May 10, 1985

SUBJECT: Calvert Cliffs Nuclear Power Plant
Unit Nos. 1 & 2; Docket Nos. 50-317 & 50-318
Inservice Inspection Program Request For Relief from ASME Code
Section XI Requirements Determined to be Impractical

SWRI LINE No.	3-PS-1002, 1002M	CALVERT CLIFFS NUC. POWER PLANT
DS&E LINE No.	3-CC11-1002, 1002M	UNIT 1
NOM. O.D./SCH.	3	P&ID(s) H-72
NOM. THICKNESS	.438	REFERENCE DWG(s).
MATERIAL	SS	FIGURE A-32
CAL. BLK.	CC-14	REV. 3 5-9-85

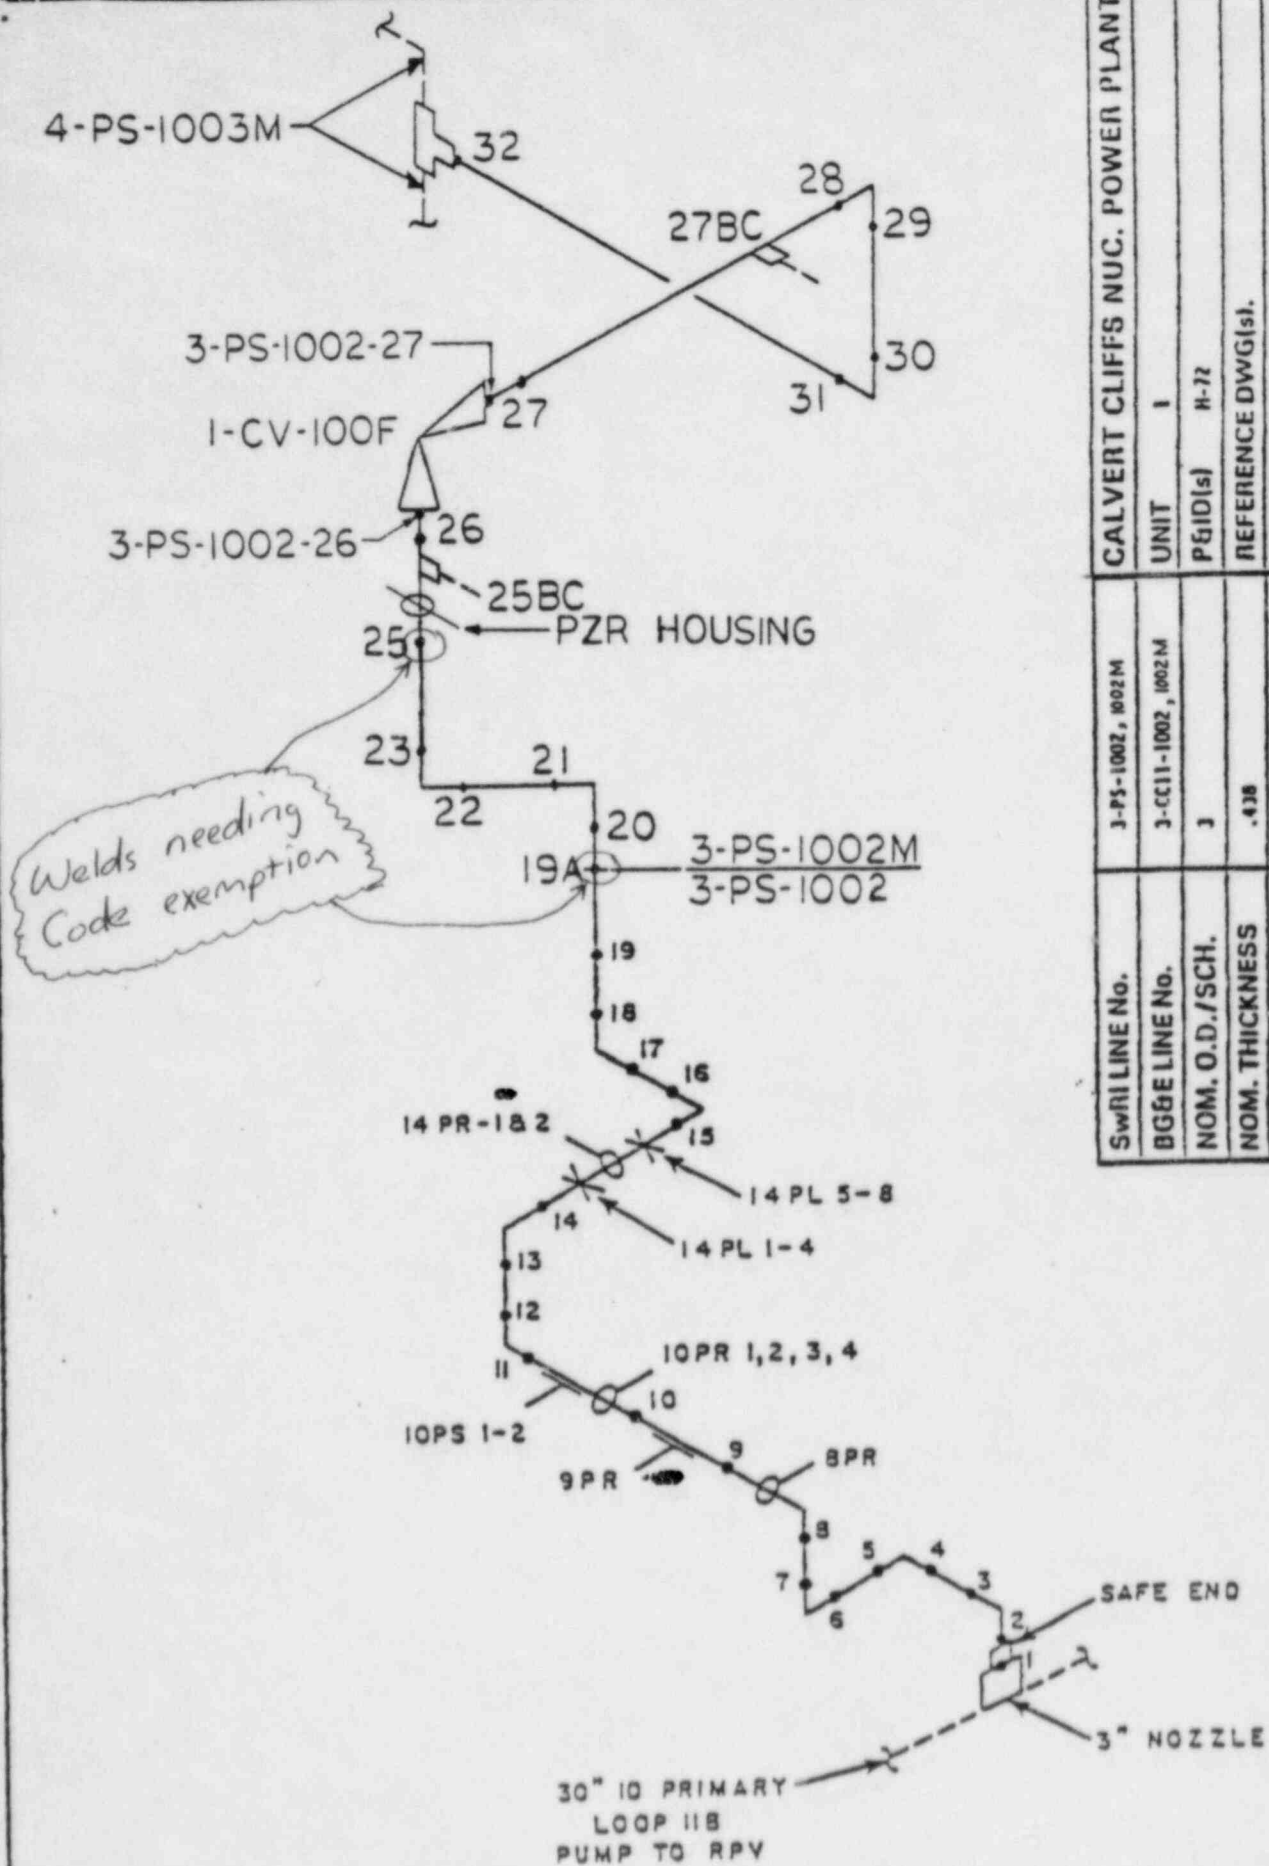
Piping line numbers 3"-CC-11-1001 and 3"-CC-11-1002 are the inlet piping lines to 1-CV-100E and 1-CV-100F respectively, from the Reactor Coolant System (RCS) cold legs. These lines are shown as 3"-CC-11-1001 and 3"-CC-11-1002 in Figure 4-1 (E-8) of the Updated Final Safety Analysis Report. The subject welds are identified in the Inservice Inspection Program as numbers 1001M-21, 1002M-25, 1001-15A, and 1002M-19A (see Attachments)

The modification was performed in accordance with ASME Code Section XI 1974 Edition with Addenda through Summer 1975. As required by ASME Code Section XI IWA-4100(c), the modification was performed in accordance with the Code applicable to the construction of the system. USA Standard B31.7-1969 with 1970 Addenda has been adhered to with the exception of a radiographic examination meeting Code sensitivity requirements on the four welds, 1001M-21, 1002M-25, 1001M-15A, and 1002M-19A, for which relief is requested.

An acceptable radiographic examination of the four welds is impossible due to the angle and distance of radiographic beam required to clear interferences such as other pipes and supports in the vicinity.

- A. Ultrasonic Examination
- B. Liquid Penetrant Examination
- C. Radiographic Examination of Root Pass (Non-code Requirement)
- D. Best Possible Radiographic Examination of Final Pass
- E. Hydrostatic Pressure Testing in accordance with ASME Code Section XI
